R66-series Lithium-Ion Battery Installation Upgrade Kit Instructions
(To comply with R66 Service Letter SL-27)

FIGURE 1
(view looking down & inboard)

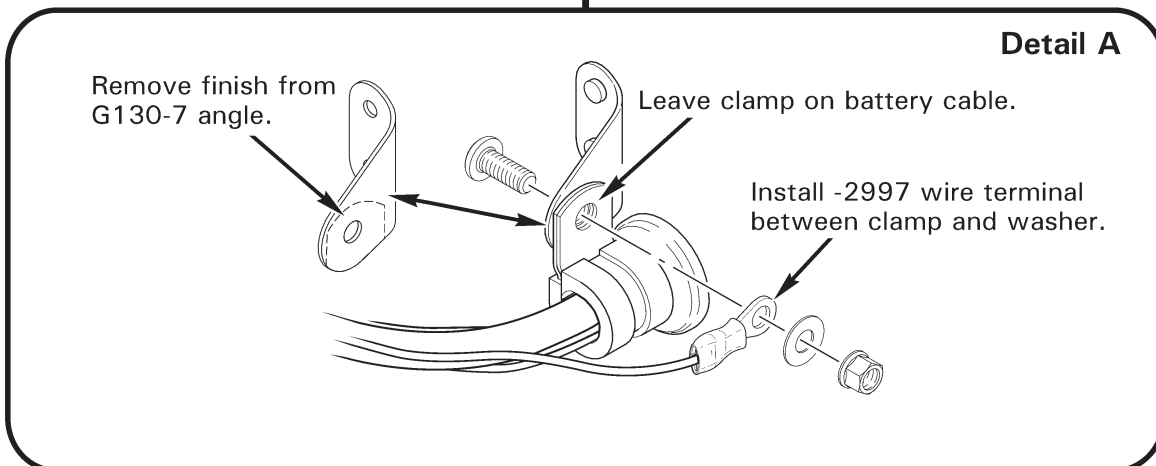
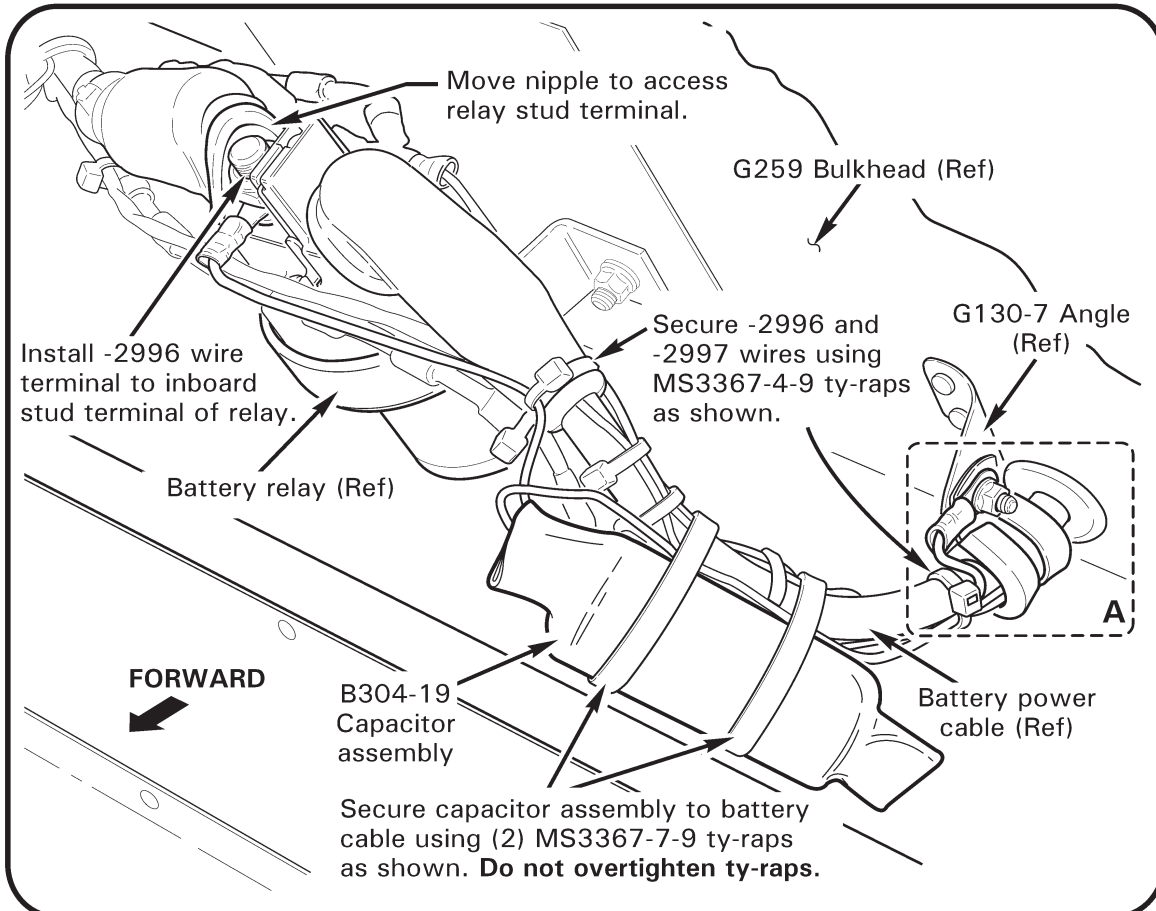
1. Disconnect battery ground (NEG) cable at battery per R66 Maintenance Manual (MM) § 96-12 B. 1 thru 6.
2. Remove aft-left backrest assembly per MM § 25-22.
3. Refer to Figure 1. Remove hardware securing clamp on battery power cable to G130-7 angle, leaving clamp on cable. Remove finish from angle at clamp installation point to ensure electrical ground (rotate clamp if necessary for access to angle). Attach clamp and -2997 wire terminal (of B304-19 capacitor assembly) to angle with hardware as shown in Detail A; verify security.
4. Access battery relay inboard stud terminal, remove nut and washer. Install -2996 wire terminal (of B304-19 capacitor assembly) and position as shown in Figure 1. Install retained washer and terminal nut. Special torque nut to 80 in.-lb. Verify security. Torque stripe per MM Figure 5-1. Position nipple over stud terminal.

5. Secure capacitor assembly to wire bundle using (2) MS3367-7-9 ty-raps. Secure -2996 wire to nipple, and -2997 wire to battery power cable using (1) MS3367-4-9 ty-rap at each location. Cinch ty-raps until snug (**do not overtighten**) and trim tips flush with heads.
